## STEUBING ESTATE NORTH

AMENDED P.O.A.D.P.  
PLAN No. 706A

The City Staff Development Review Committee has reviewed Steubing Estate North Development Plan M.D.P. (formerly POADP) Preliminary Overall Area Development Plan # 706-A. Please find enclosed a signed copy for your files. Your plan was accepted however please note the following:

City of San Antonio  
Planning Department  
Master Development Plan Section  
**REQUEST FOR REVIEW**

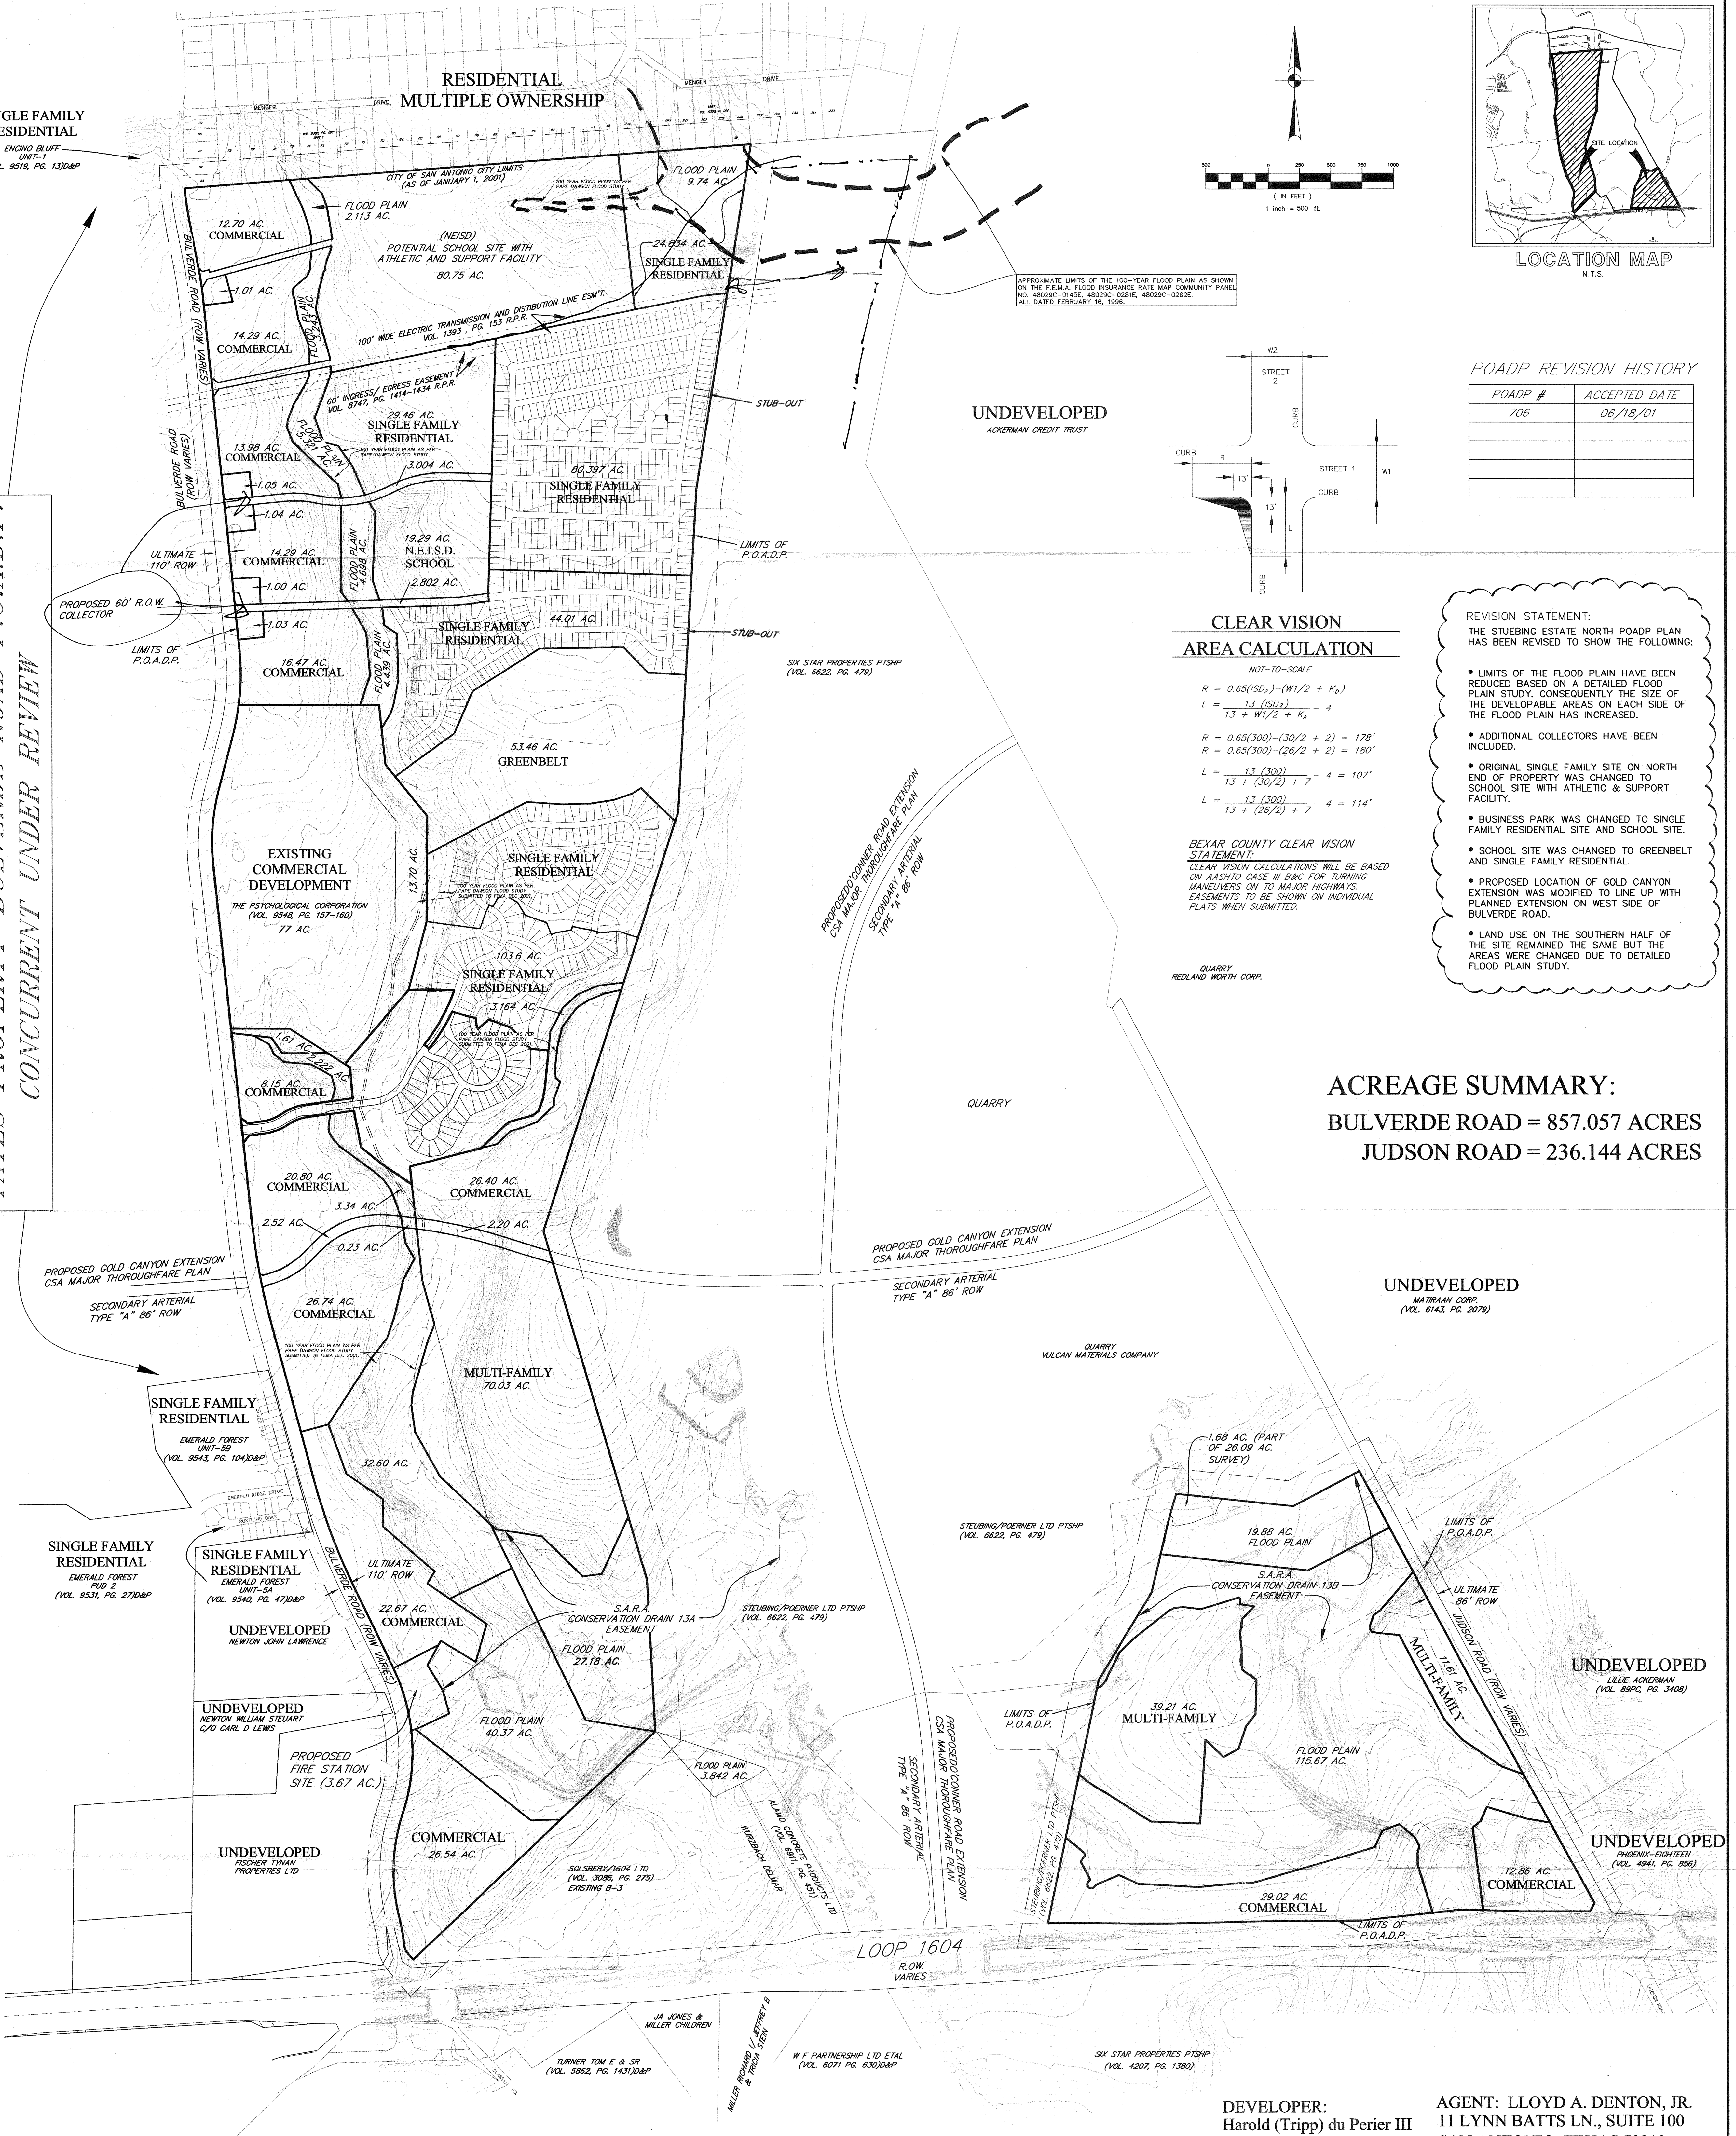
PLEASE SHOW ZONING FOR CLARIFICATION.

Comments: More detailed information is  
required on this proposed  
development. (Stevling Estates North)  
before approval is recommended.  
Both parcels are adjacent and  
upstream of Dams 13A & 13B.  
The HEC-1 runs for the 1997  
Vickerey Report indicate that  
the dams do not contain the  
100 year flood for the ultimate  
condition. Therefore, both  
parcels must provide detention  
such that the elevation above  
the 100 year flood (ULTIMATE) is  
not increased. Storm Water Engineer  
is currently assessing new information  
whereby the Q ULTIMATE will be  
higher.

FIGURE 22  
PHASE I  
DRIVEWAY LOCATIONS

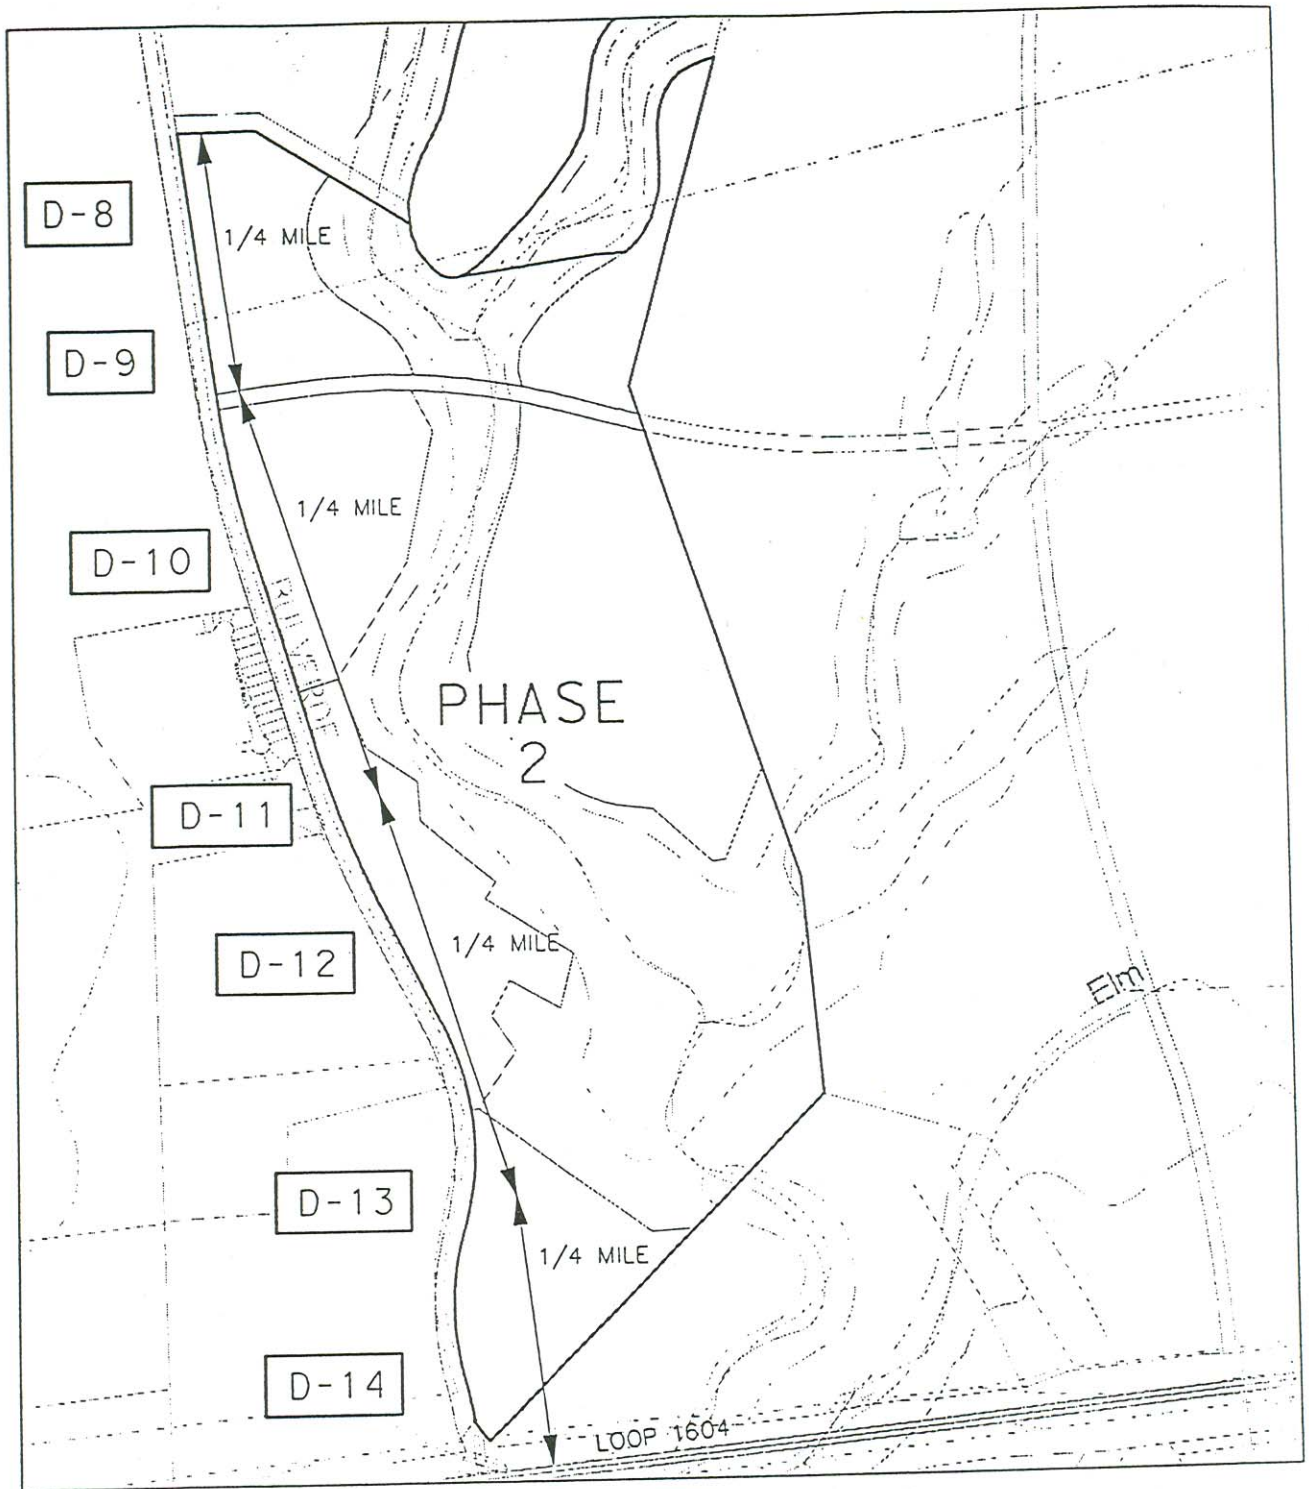
Proposed driveways for Phase 1 are illustrated in Figure 22. The following driveway/collector roadways should be designed to maximize intersection capacity, including dual westbound left-turn lanes, left-turn lane southbound, right-turn lane westbound, and right-turn lane northbound for Driveways 3, 4, 6 and 7. Final placement of these driveways should be spaced to provide either ¼ mile or ½ mile spacing between these planned signalized locations.

FIGURE 24  
PHASE 3  
DRIVEWAY LOCATIONS

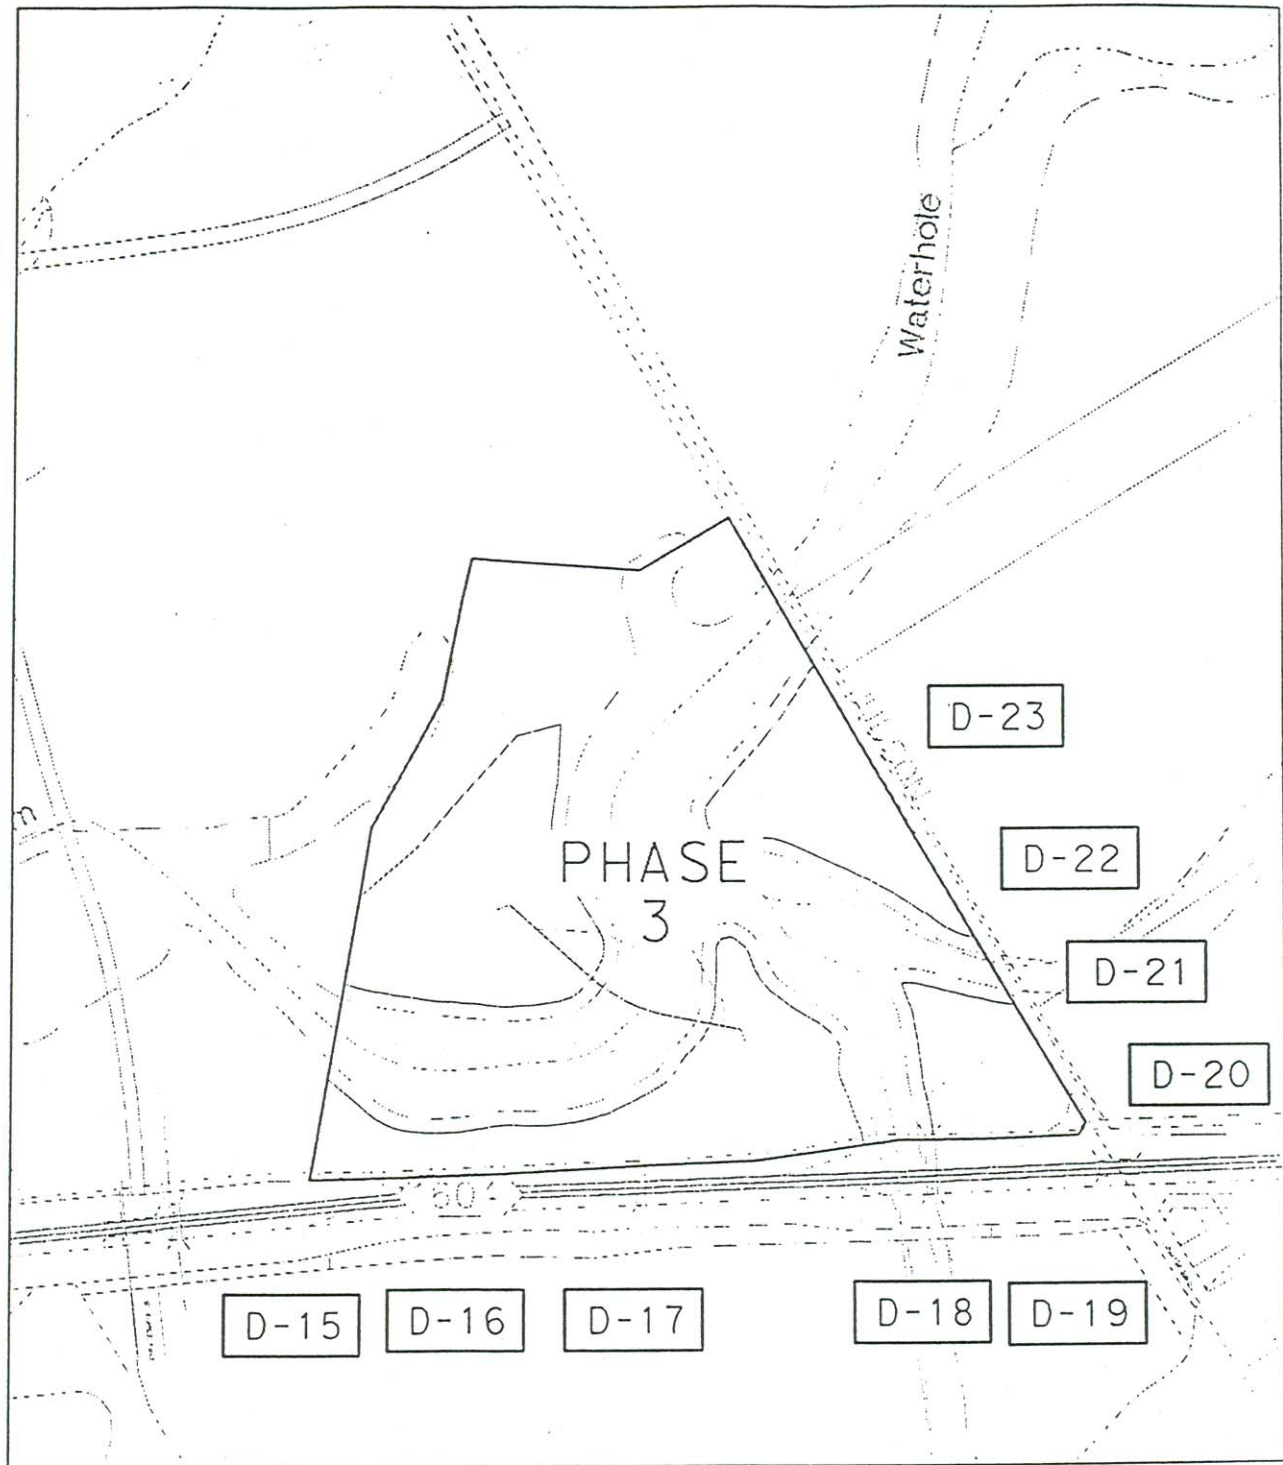
Traffic signals will be required by 2010 at the interchanges of O'Connor Road and Judson Road. Under these signalized conditions, no additional mitigation will be necessary. Proposed project driveways are illustrated in Figure 24. Left-turn lanes should be constructed at Driveway 20, 21, 22 and 23 along Judson Road to provide access for Tracts 18 and 20. Right-turn lanes should be provided along the westbound frontage road of North Loop 1604 for access to tracts 17, 19, and 20. Since Tract 17 does not have direct access to the frontage road a major shared access point should be located to serve Tract 17 and 19.
